V2500-A1/A5/D5 SERIES PROPULSION SYSTEM NON-MODIFICATION SERVICE BULLETIN

This document transmits the Initial Issue of Non-Modification Service Bulletin V2500-ENG-73-0229.

NON-MODIFICATION SERVICE BULLETIN – ENGINE FUEL AND CONTROL – INSPECTION OF THE
VARIABLE STATOR VANE ACTUATOR (VSVA) AND THE HIGH PRESSURE (HP) SERVO FUEL TUBE FOR
CHAFING

Variable Stator Vane Actuator (VSVA)
Figure 1 (Sheet 1 of 2)

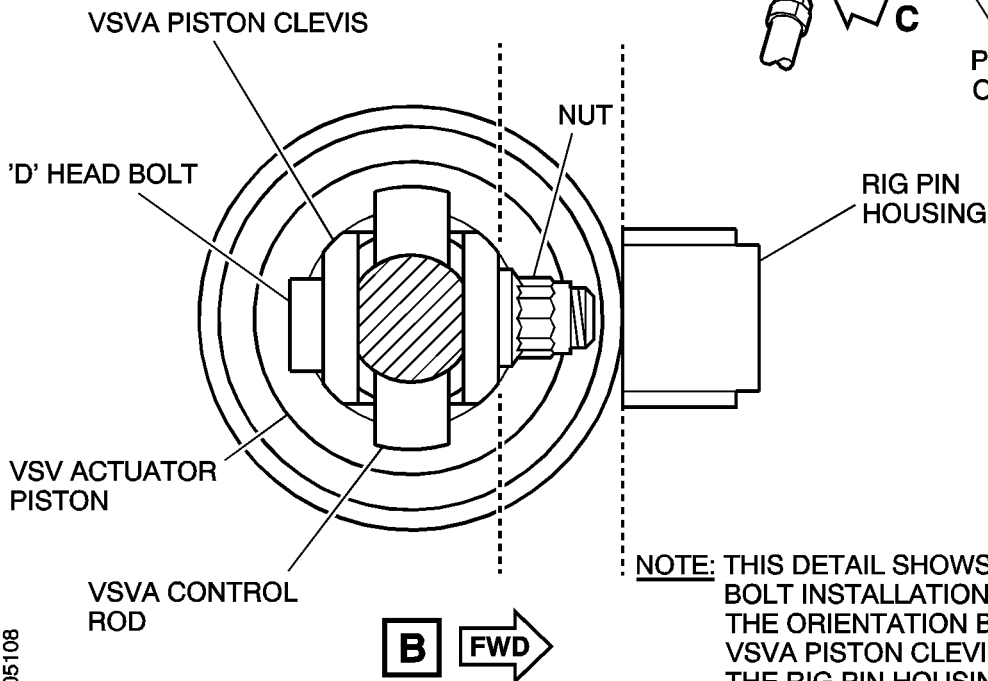
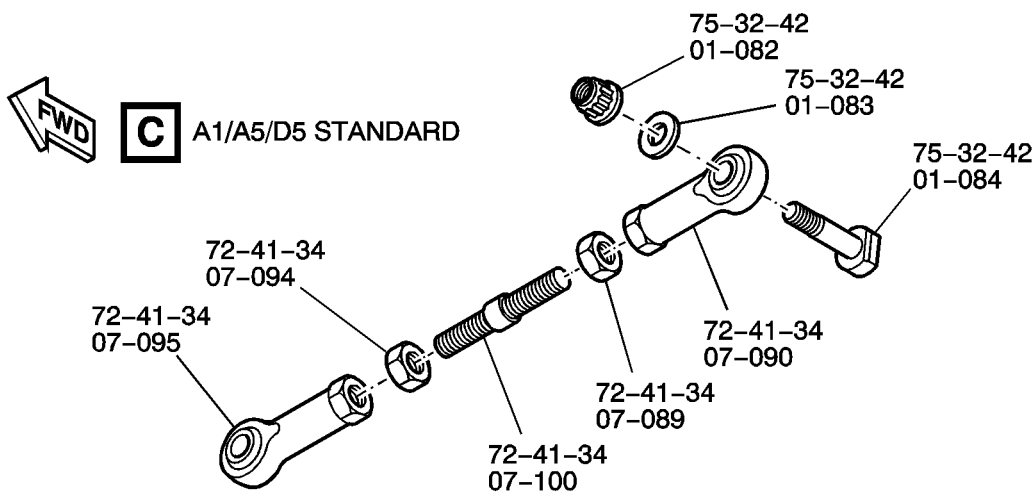
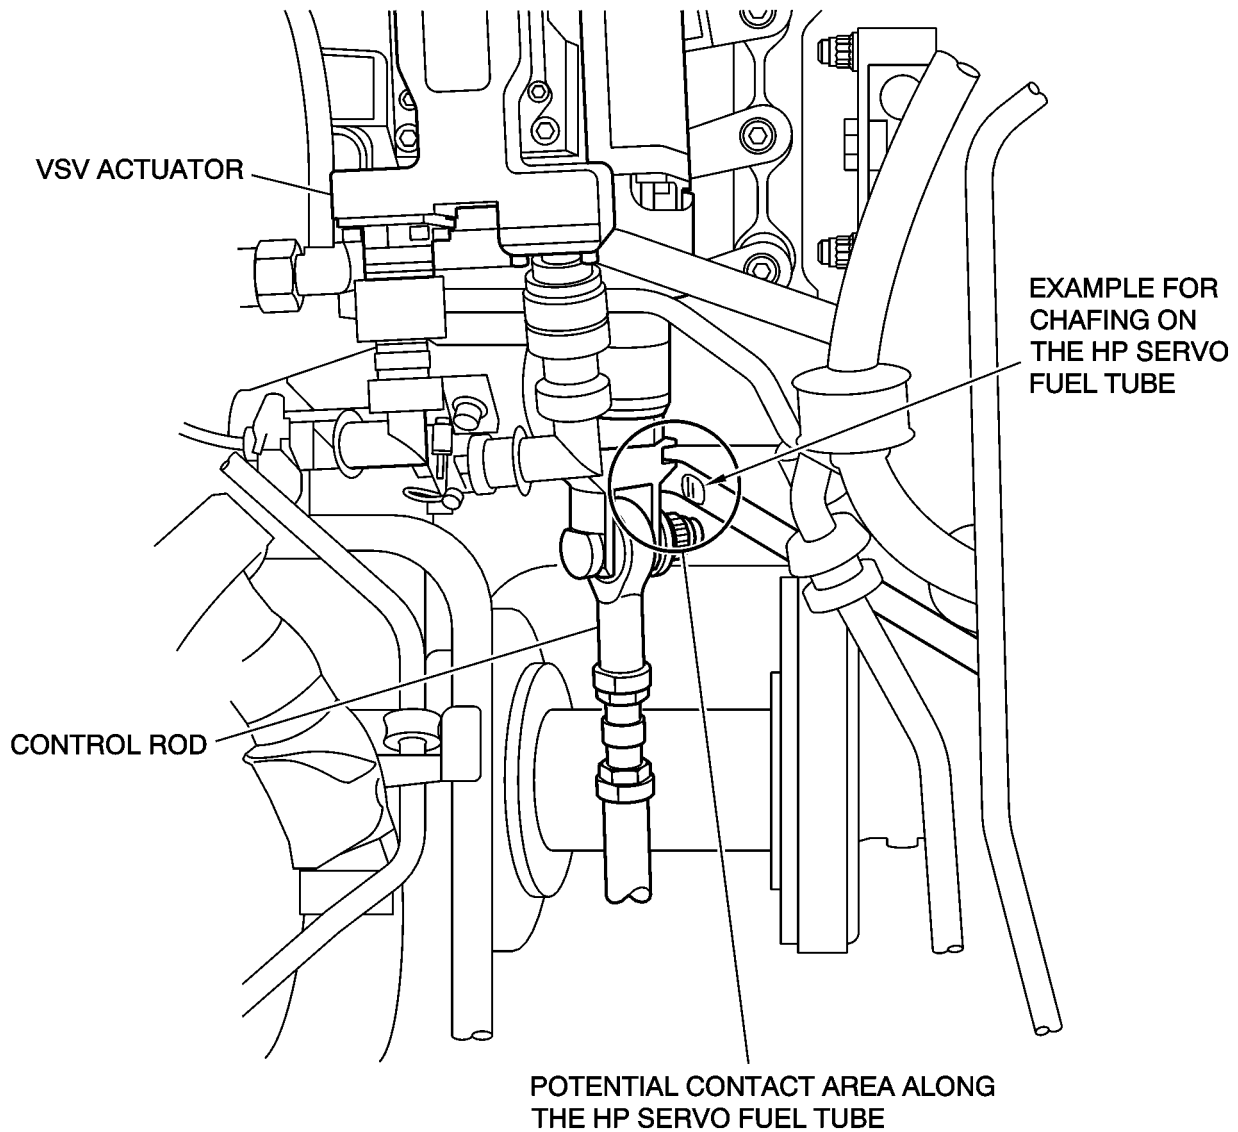
- (ii) Make sure that the VSVA piston clevis is aligned correctly (Refer to Figure 1, detail B).
 - (iii) If the VSVA piston clevis is found aligned correctly, do the steps that follow:

- (iv) If the VSVA piston clevis is found misaligned and/or the VSVA control rod connection bolt (75-32-42, 01-084) is found incorrectly positioned/installed, make a check of the VSVA piston clevis, the VSVA rig pin housing and the VSVA control rod bolt for damage.

- (1) Tighten, torque and secure the lock nuts (72-41-34, 07-089) and (72-41-34, 07-094) on the VSV actuator control rod assembly in accordance with Service Bulletin V2500-ENG-72-0633.

- (1) If damage is found, replace the VSVA (75-32-41, 01-100) and/or the VSVA control rod bolt (75-32-42, 01-084) (Refer to the Aircraft Maintenance Manual, Chapter 75-32-41 Removal/Installation).

Variable Stator Vane Actuator (VSVA)
Figure 2

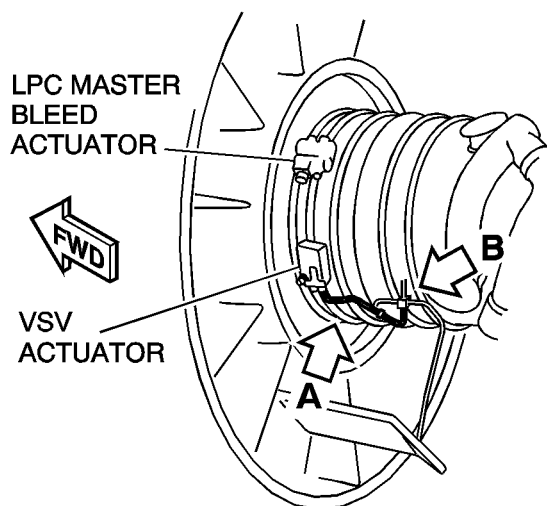
- (i) Inspect the HP servo fuel tube (73-11-49, 12-500) for chafing (Refer to Figure 2).

NOTE: THE VSVA CLEVIS AND CONTROL ROD END ARE SHOWN INCORRECTLY POSITIONED.

(2) If the HP servo fuel tube (73-11-49, 12-500) is found chafed, replace the HP servo fuel tube (73-11-49, 12-500).

Variable Stator Vane Actuator (VSVA)
Figure 3 (Sheet 1 of 3)

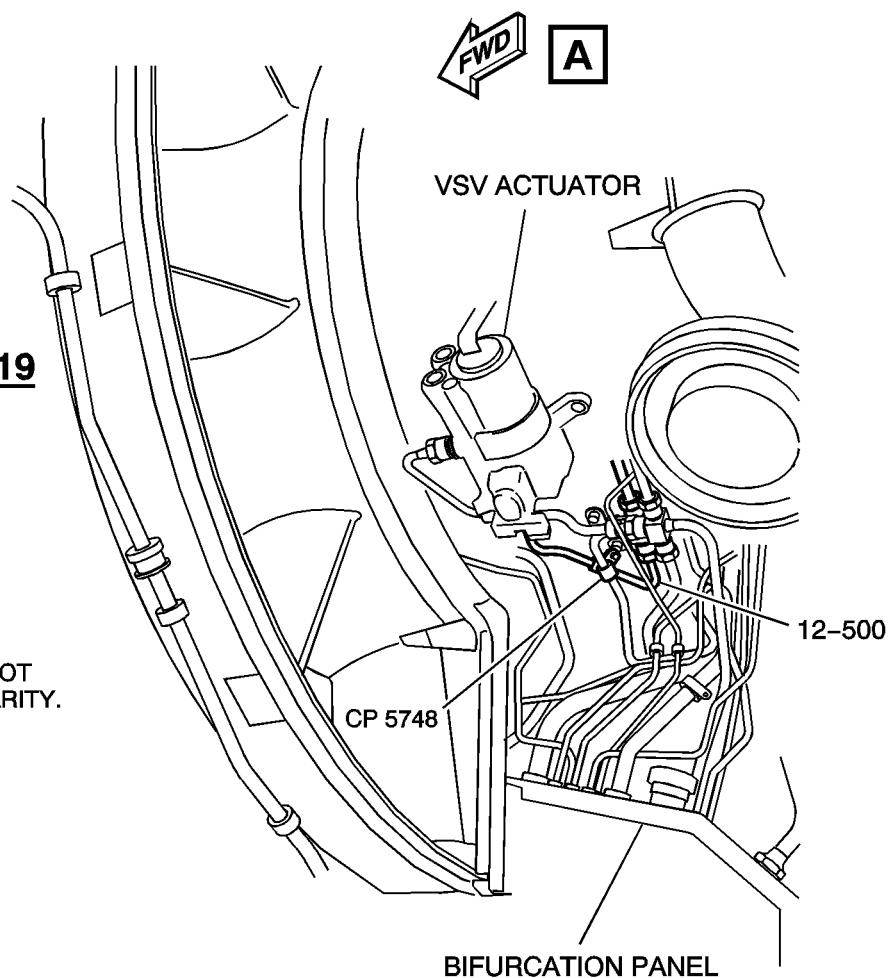
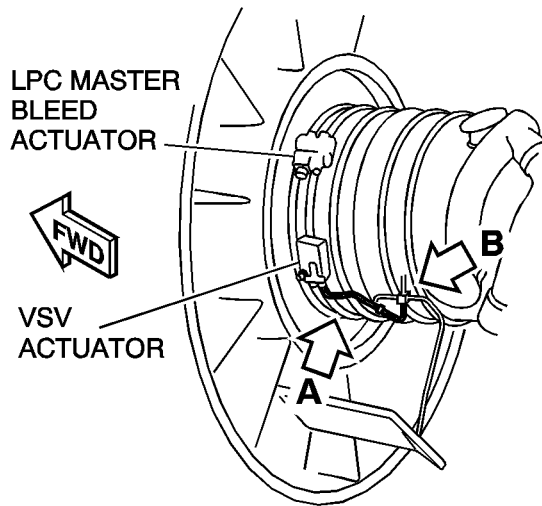
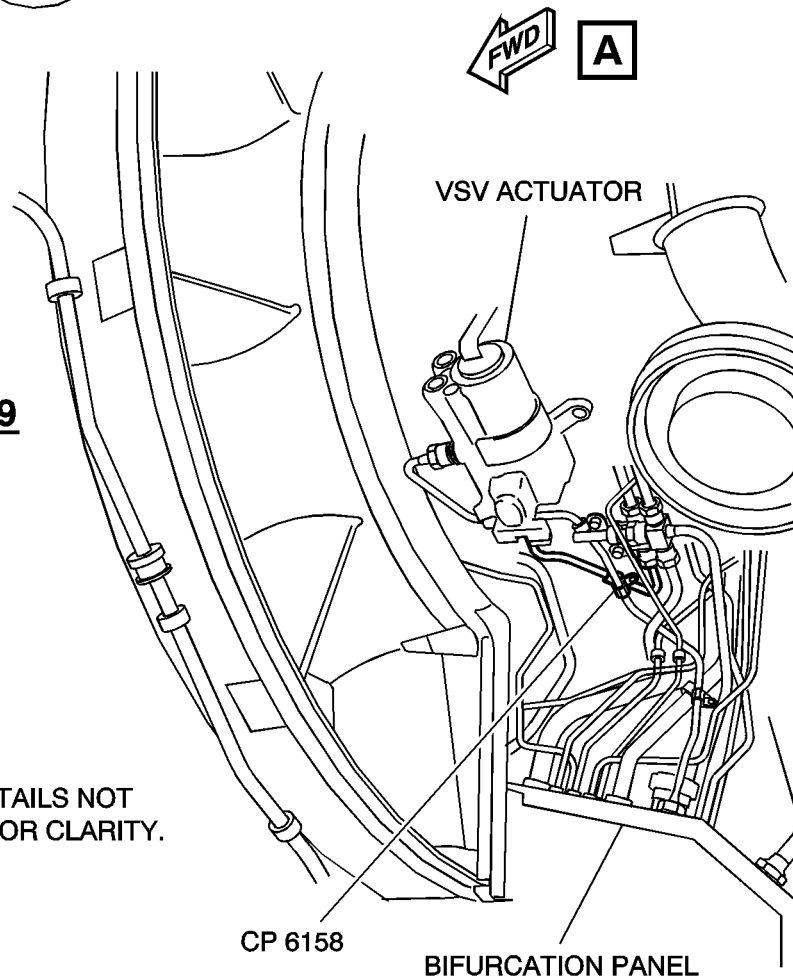
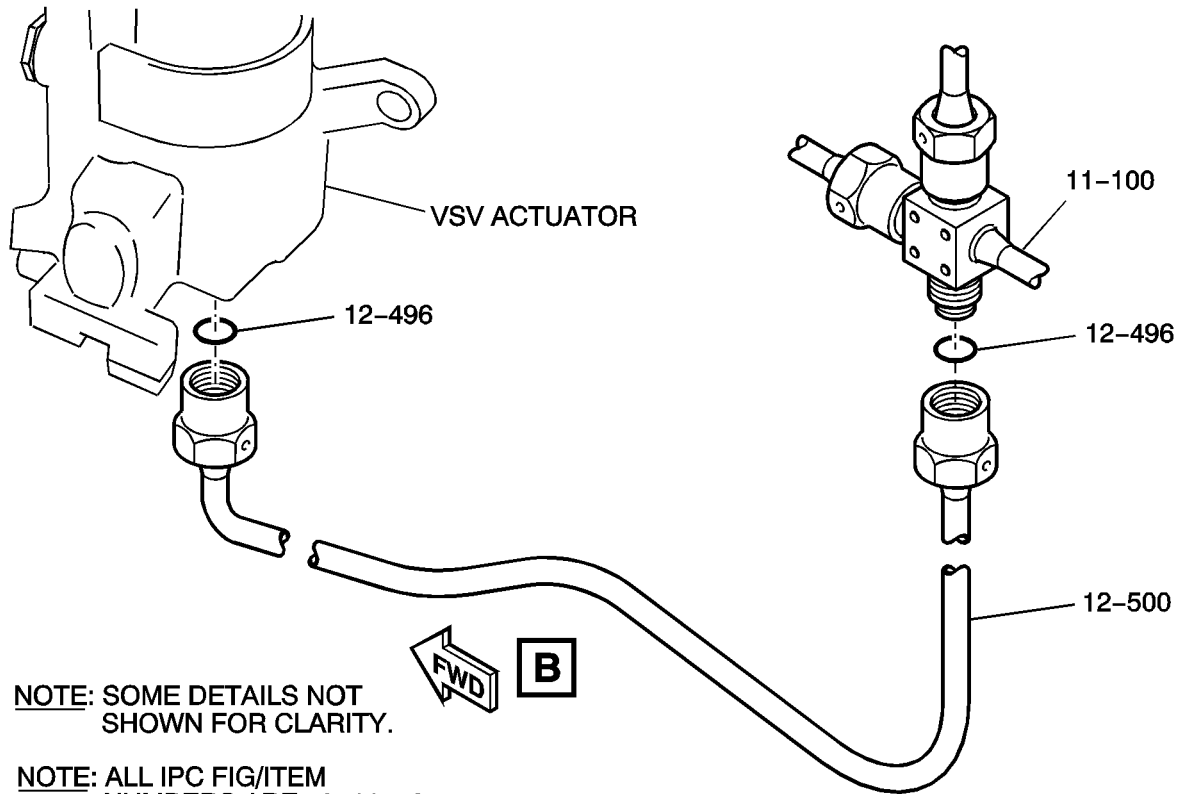
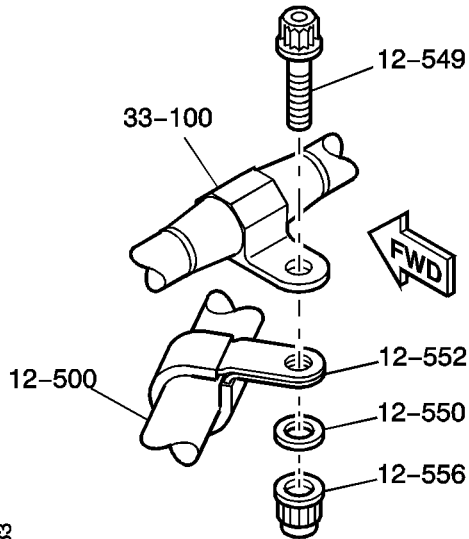
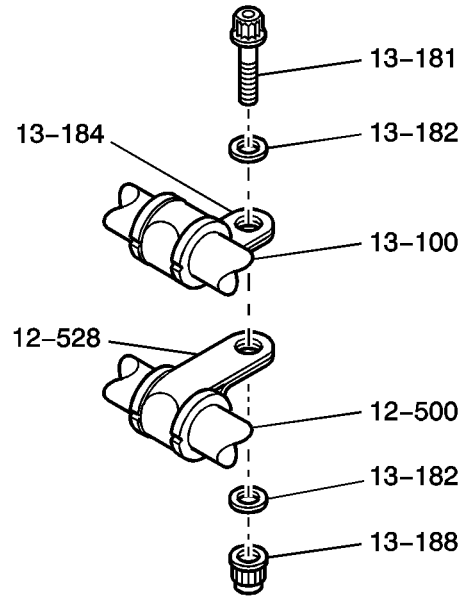
(c) Replace the HP servo fuel tube (Refer to Figure 3)

- (i) Remove the nuts, bolts and washers that attach the clips at clip positions CP5748 or CP6158

At the clip position CP5748, install the bolt (73-11-49, 13-181), the two washers (73-11-49, 13-182) and the nut (73-11-49, 13-188) that attach the clip (73-11-49, 12-528) to the clip (73-11-49, 13-184).
 - (2) For SBE 73-0219 engines:

At the clip position CP6158, install the bolt (73-11-49, 12-549), the washer (73-11-49, 12-550) and the nut (73-11-49, 12-556) that attach the clip (73-11-49, 12-552) to the lug on tube (73-11-49, 33-100).
- (xi) Make a check that the tube (73-11-49, 12-500) is installed with the correct clearances and without tension.
- (xii) Torque the nuts (73-11-49, 13-188) and (73-11-49, 12-556) to 35.4 to 44.3 lbf in. (4 to 5 Nm).

(xiii) Use a crowsfoot spanner to torque the tube connectors of tube (73-11-49, 12-500) to 425 to 475 lbf in. (48 to 53,7 Nm).
